*Re: Focus: Traffic
Additional Comment & Expert Review Regarding Development Proposal for Bishop Tube site by
Constitution Drive Partners*

To: Maya van Rossum, the Delaware Riverkeeper
From: Mark L. Stout
Project: Bishop Tube development
Subject: Traffic and accessibility analysis, preliminary report
Date: 24 June 2019

Figure 16, underpass walkway design, excerpt from Sheet 24, Revised Preliminary Land Development Plan

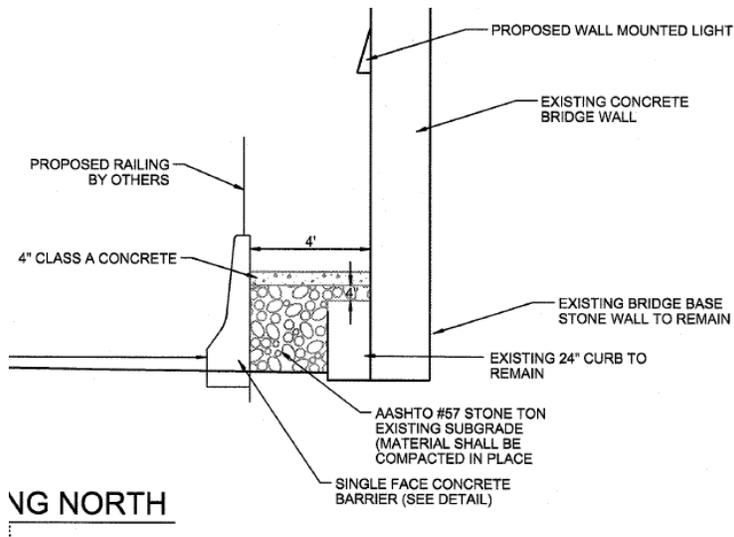
Second, the Plan appropriately calls for a pedestrian walkway protected by a Jersey barrier and railing under the overpass (Sheet 24). In order to keep the existing concrete curb (figure 15) in place (presumably for structural reasons), without reducing the cartway width even further, the design in the Plan would build the walkway over the curb, at a height approximately 32" above the surface of the road (figure 16). This raises design issues for accessible ramps between grade level and the level of the walkway and for a safe railing system in the underpass.
